REQUEST FOR DEVIATION/WAIVER (RFD/RFW)

7. DESIGNATION FOR DEVIATION/WAIVER

10. TITLE OF DEVIATION/WAIVER: CHANGE IN TOOL BOX

13. CONFIGURATION ITEM NOMENCLATURE: NITROGEN CHARGING KIT

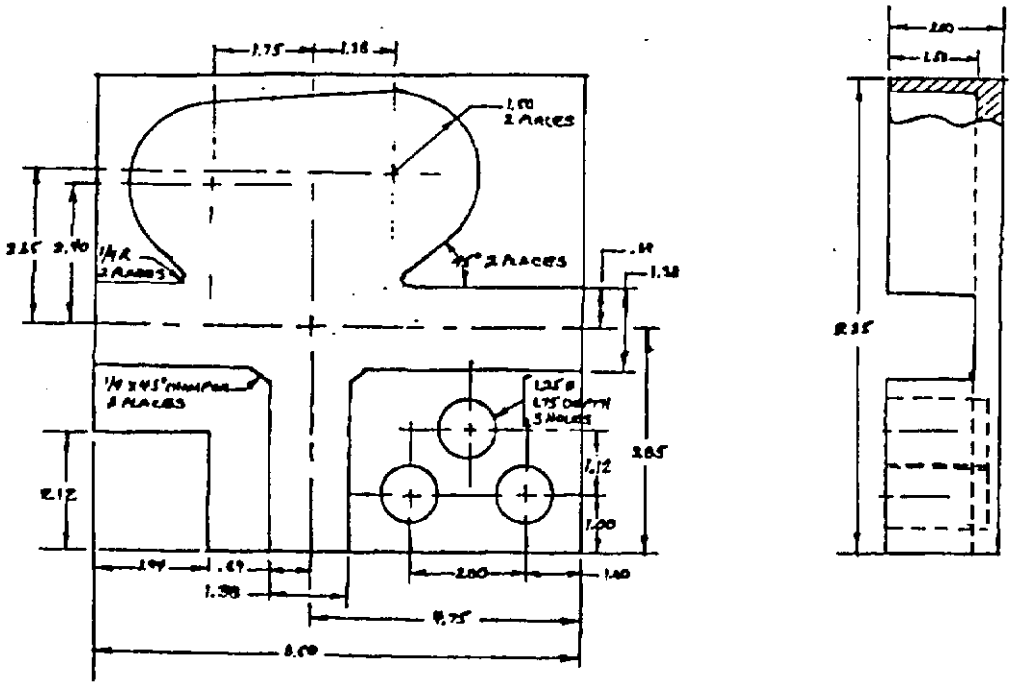
REVISE DESIGN OF INSERT OT ACCOMODATE THE USE OF VICTOR MODEL SR4J-580 REGULATOR IN LIEU OF CIRCLE SEAL MODEL 1R12580G. PROPOSED INSERT SHALL BE PER ATTACHED AERO PRODCUTS INSERT DRAWING APC09336.

RECOMMENDED TOOL BOX AND REGULATOR ARE DIFFERENT CONFIGURATION THAN THOSE SPECIFIED

g. APPROVAL: [X] APPROVED as modified [ ] DISAPPROVED
